Tuesday 7 April 2020  
Ref: 7922/S/LT/001

7, Branch Hill, London, NW3 7LT  
Section 73 Application - Basement Impact Assessment

The amendment to the proposals relates to a reduced extent of basement, as shown on the current structural drawings included in Appendix B. The 2018 scheme drawings are included in Appendix A for comparison.

**Proposed Lower Ground Floor Plan**

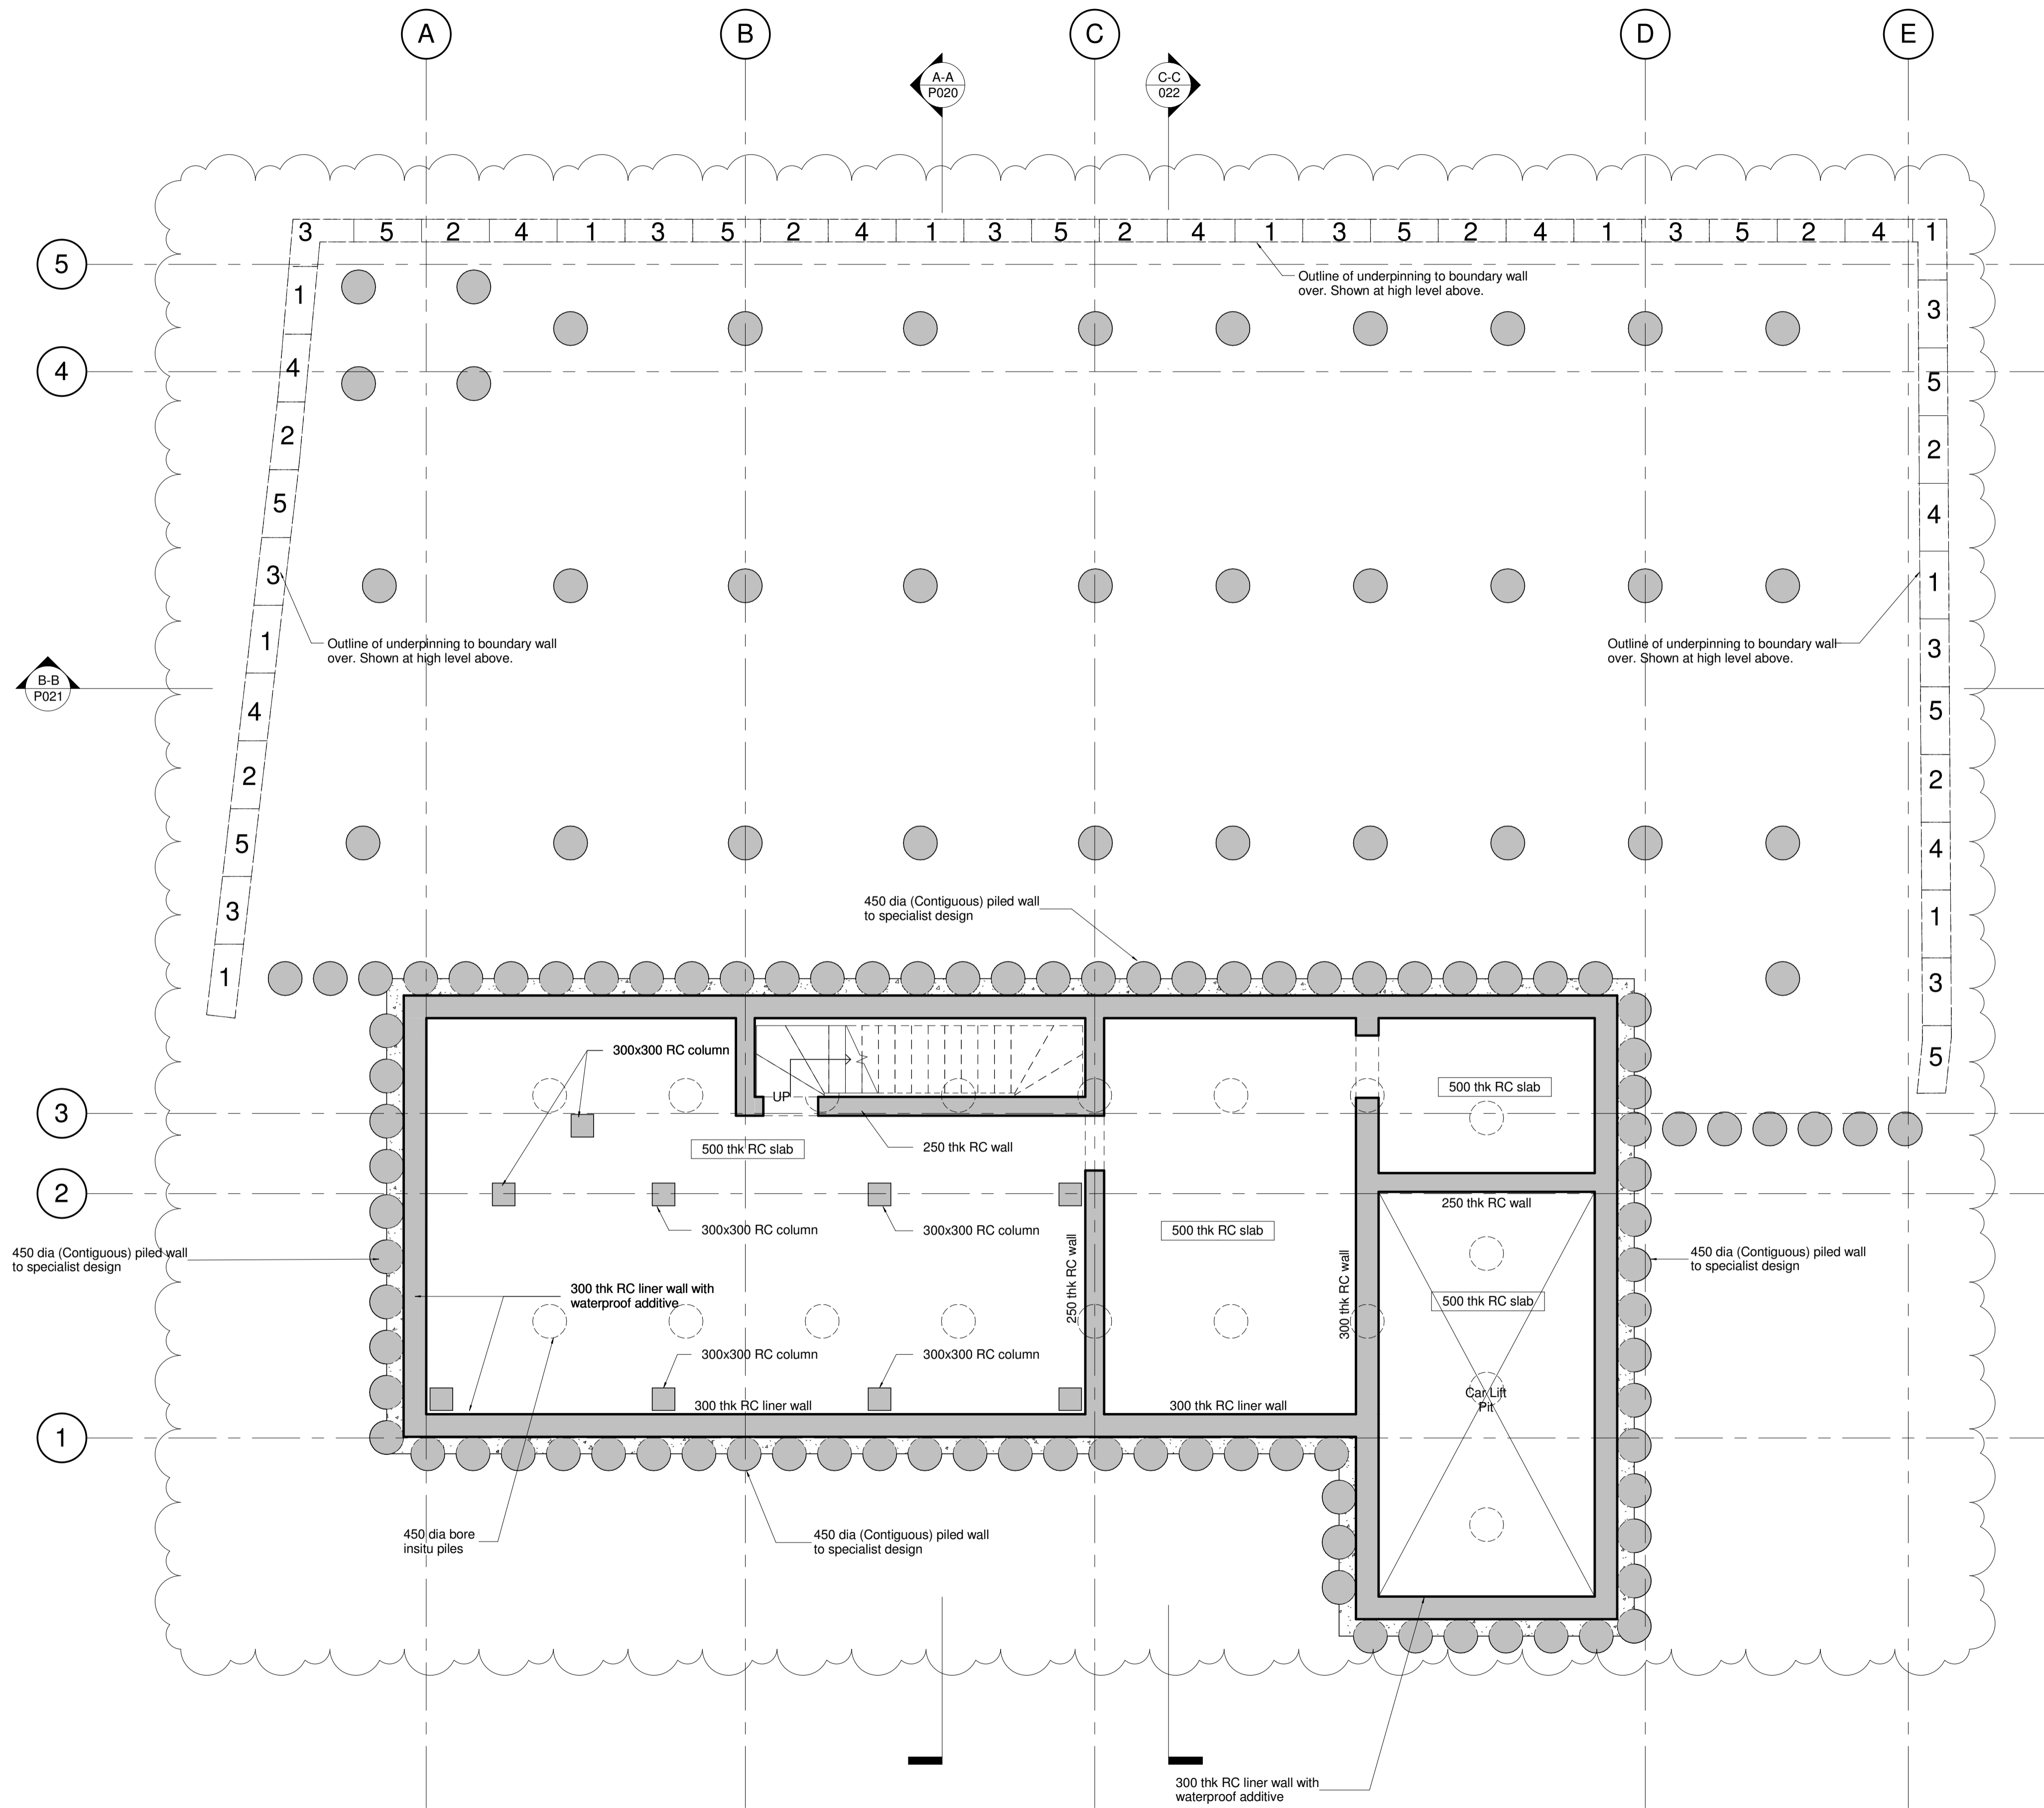
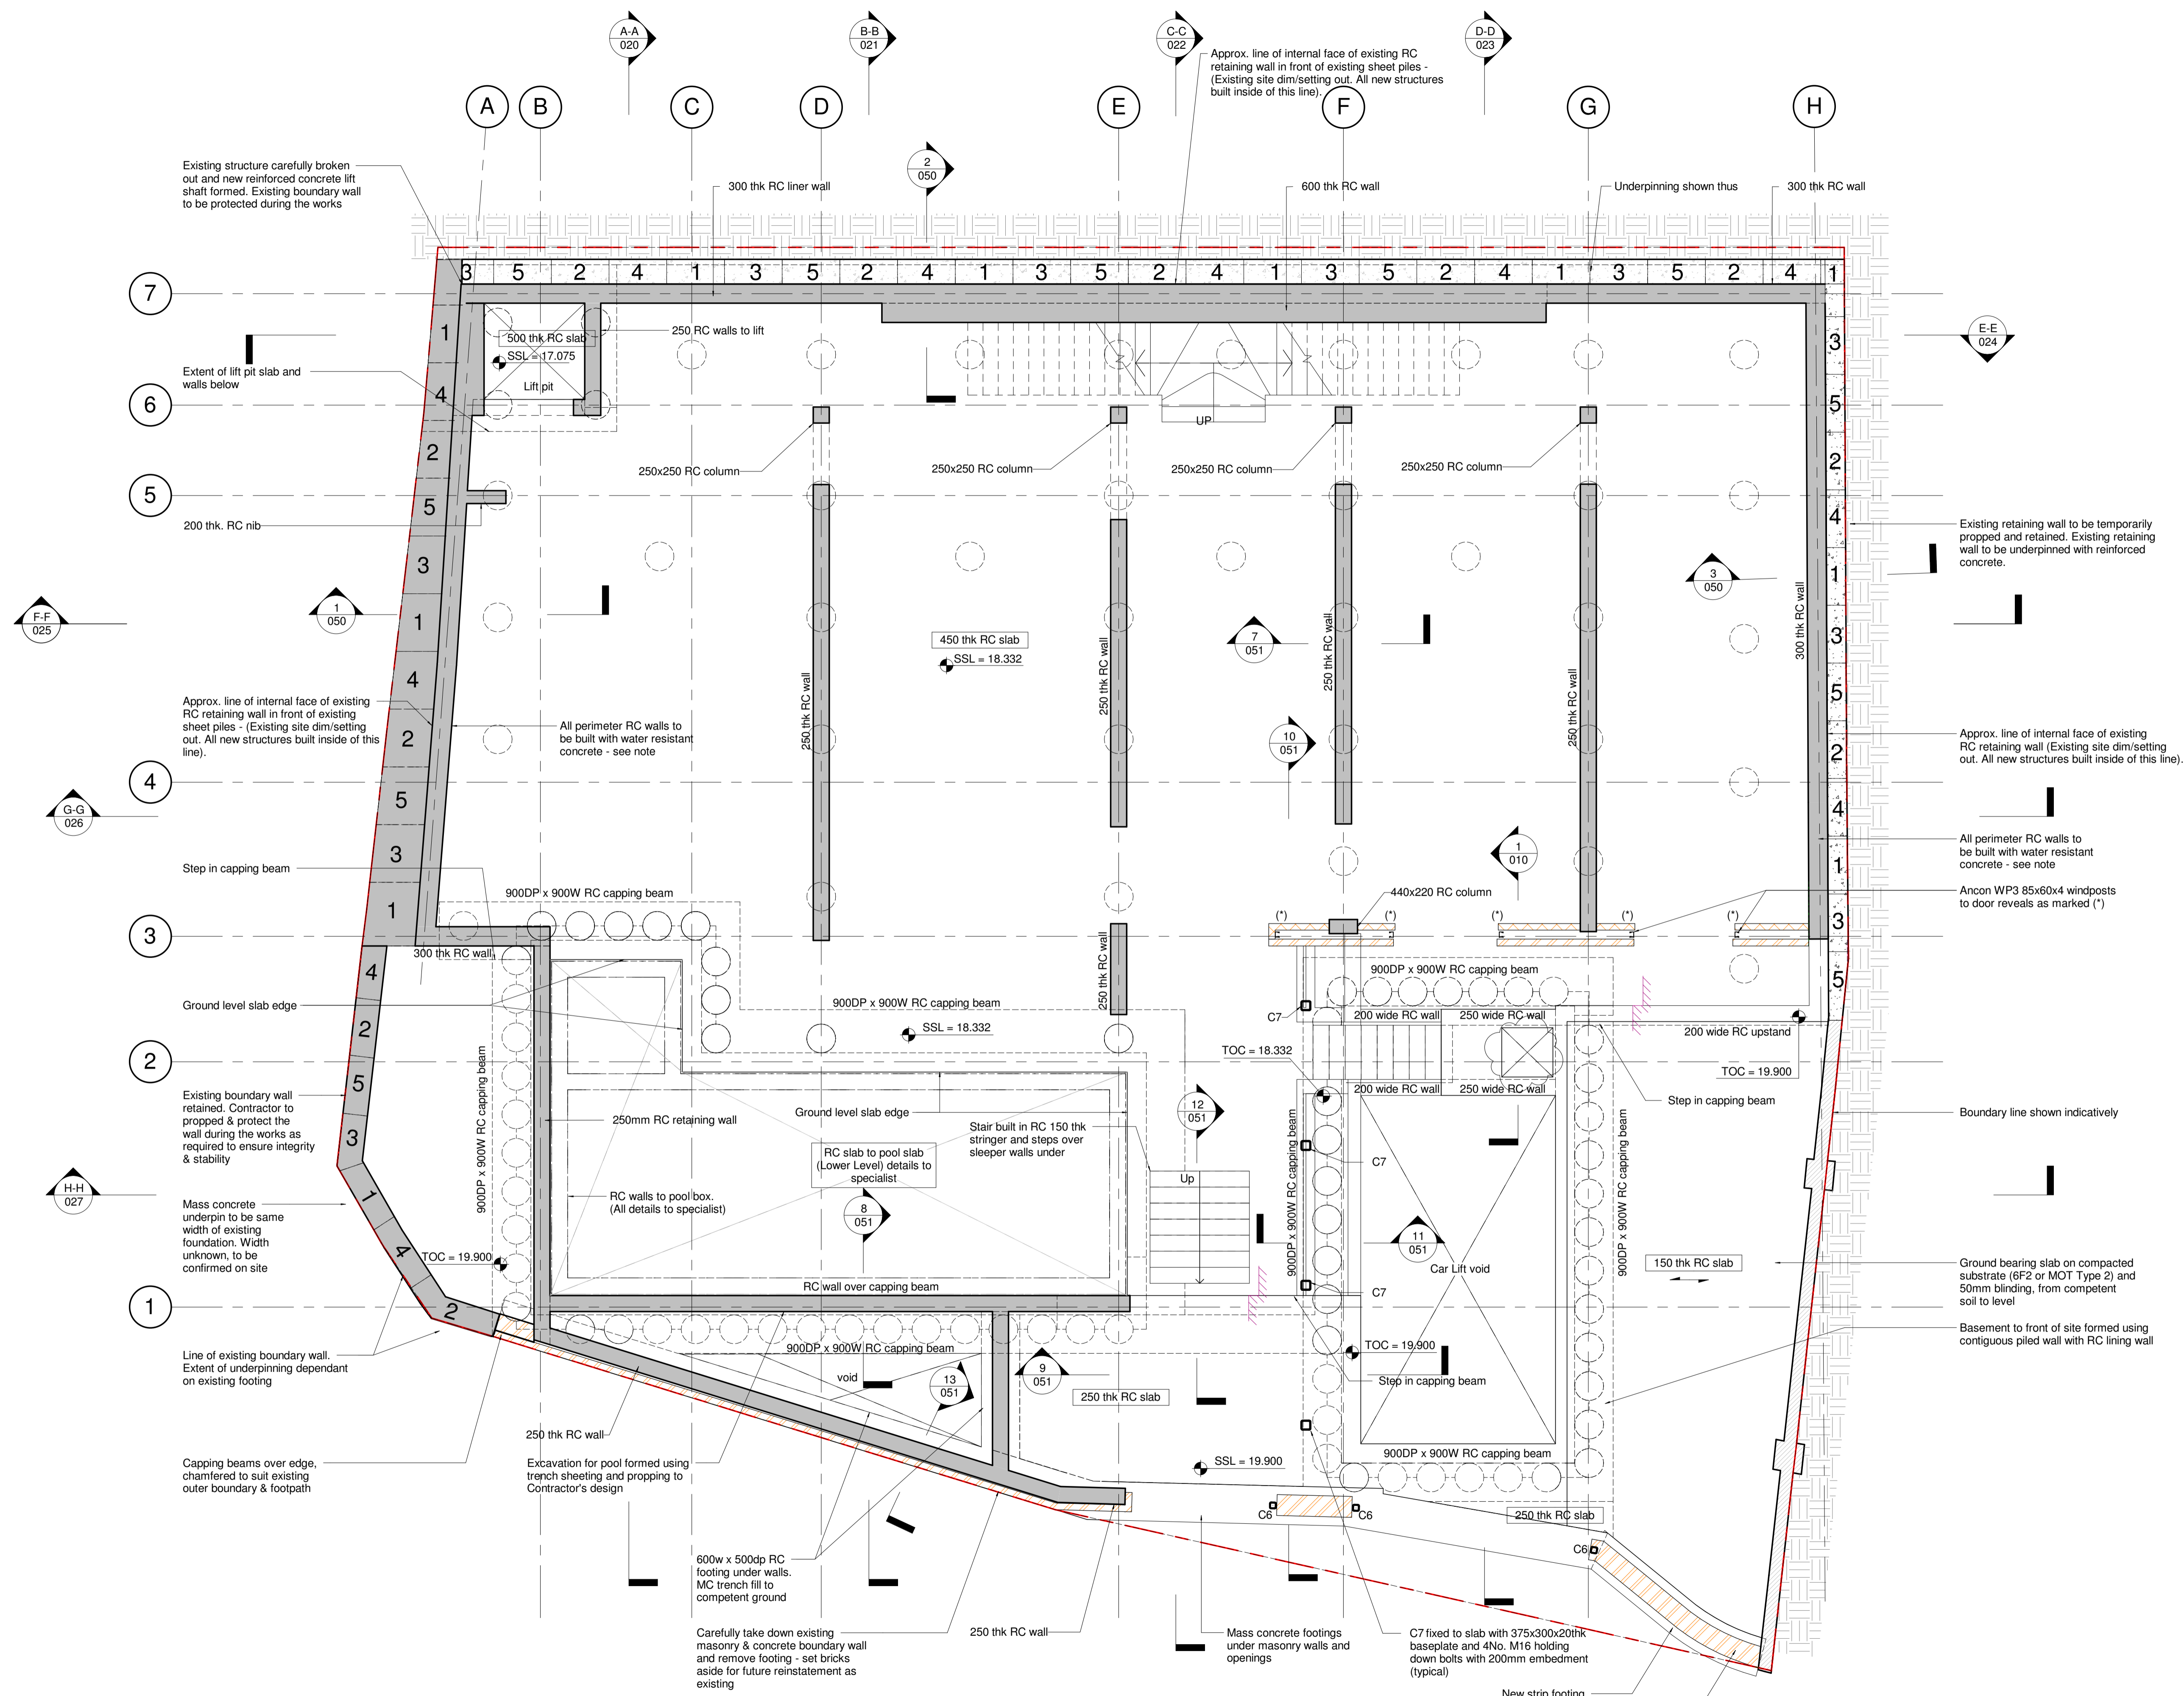
The 2018 Basement Impact Assessment was prepared for a larger new basement, but the extent of the new basement has now been reduced, as noted below:

- Basement footprint to Branch Hill side reduced.
- Shallower excavation for the pool area.

that the revised basement layout will have no material effect on the findings and conclusions of the 2018 Basement Impact Assessment.
